**► AIRCRAFT**

**SUBJECT:** IGNITION SWITCHES, ROTARY ACTION, KEY OR LEVER ACTUATED, TWIST-TO-START, PUSH-TO-START, TWIST-TO-START/PUSH-TO-PRIME TYPES.

**REASON FOR BULLETIN:**

**Figure 1. Identification of Switch Parts.**

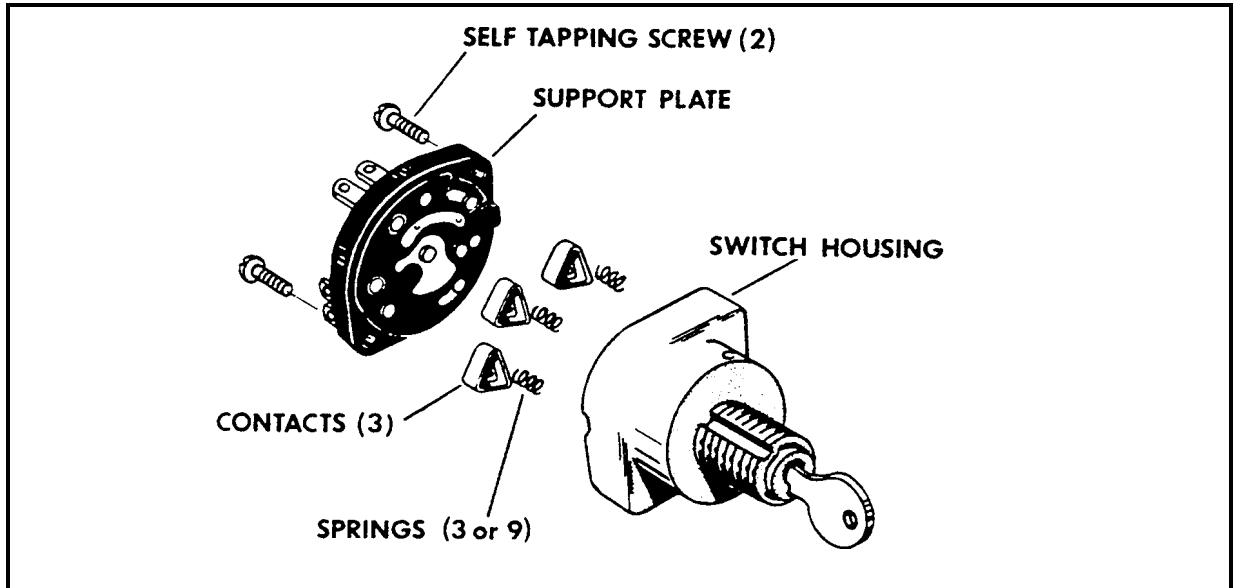
B. To install a new Support Plate and Contacts, proceed as follows using Figure 1 as a guide for parts identification.

- a. Hold switch in a vertical position, support plate up.
- b. Using firm finger pressure, hold the support plate against the switch housing while removing the two self tapping screws. Retain screws for use during reassembly.

c. Directly beneath the support plate are three contacts, spring loaded against the support plate. Carefully separate the support plate from the main switch assembly and remove the three contacts and springs (3 or 9).

d. Retain the springs for use during reassembly. Discard the old support plate and contacts.

- a. Reinstall contact loading springs (3 or 9) in rotor. Position new contacts over springs so contacts will move into triangular recesses when pressure is applied.
- b. Locate boss on new support plate over locating slot in switch housing

and carefully install support plate to housing, observing that contacts move in recesses.

- c. Holding plate against housing, turn key or lever through all switch positions. If it does not turn freely through the detent position, recheck contact, springs, and support assembly.
- d. Once switch operation is satisfactory, reinstall and tighten self tapping screws holding support plate to switch housing.
- e. After switch has been completely reassembled, check it for ease of operation. There shall be little or no drag between stops. Check for positive stops in all positions. Check switch action for a positive and free spring return from the "START" position to the "BOTH" position. The switch shall not spring back beyond or "overtravel" the "BOTH" position.
